## ***Interactive comment on “Modeling the Glacial Lake Outburst Flood Process Chain in the Nepal Himalaya: Reassessing Imja Tsho’s Hazard” by Jonathan M. Lala et al.***

**Jonathan M. Lala et al.**

Received and published: 25 May 2018

**Fig. 1.** WorldView-2 (0.5 m; DigitalGlobe, Inc.) imagery of the lake before (14 May 2016) and after (29 October 2016) the lake lowering project

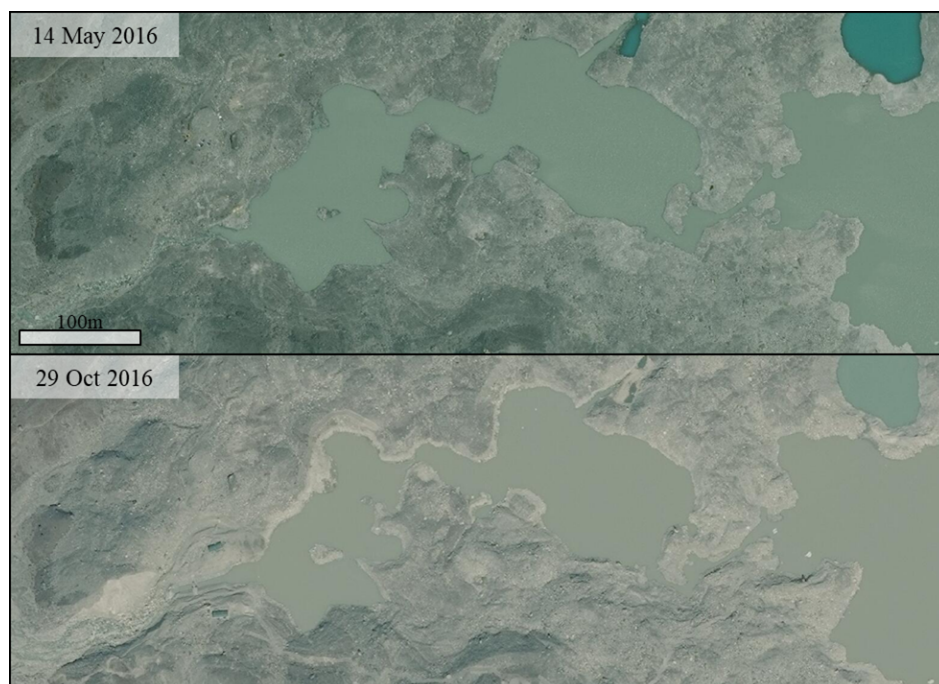
*First, the authors have made a good case here for undertaking this study, and have outlined clearly how their modelling approach compares with previous efforts. This indicates novelty in their work. However, Imja Tsho made headlines in October 2016 when the Nepalese Army were deployed to undertake some engineering work to lower the lake, and thereby reduce GLOF hazard. Whilst the authors allude to this recent change briefly in the Introduction (P2 L23), it seems that this change (reported by the BBC to be a lowering of 3m) has not been considered in this study. For example, the bathymetric survey undertaken by the authors was completed in June 2016, several months before the lake lowering. Ultimately, my question here is: to what extent does the manual lake lowering affect the relevance of your results? For example, maybe the lake lowering by the army is insignificant in the grand scheme of things because the glacier will continue to recede (as you say in section 2.2), and occupy new overdeepenings, etc. But I think there should be more mention and consideration of this recent change in the size/volume of the lake.*

The reviewer rightly points out that the lake lowering project is only mentioned briefly, and it is true that a significant lowering of the lake level would affect the results. Imagery from before and after the lake lowering (Figure 1 in this response, Figure 3 in revised manuscript) shows a clear ring of discoloration and decrease in area at the outlet ponds, but not in the main part of the lake, indicating that the latter may not have been lowered to the same extent. The authors decided to remain conservative in

the hazard assessment by assuming that the lake was not lowered. A paragraph has been added to section 2.2 and reads as follows: "Although the lake was subjected to a lowering project in the summer of 2016 that reportedly lowered the lake by 3 m (BBC World Service, 2016), this lowering was not accounted for in the GLOF process chain modeling as it is unclear how much the main lake was lowered based on repeat satellite imagery (Figure 3). Specifically, WorldView-2 (0.5 m; DigitalGlobe, Inc.) images of the lake's outlet complex before and after the lowering project show a clear ring of discoloration and decrease in area around the outlet ponds, but the lack of discoloration near the shore of the main lake suggests that the main lake may not have been lowered to the same extent. Hence, the GLOF process chain was modelled conservatively by not accounting for any lake lowering."
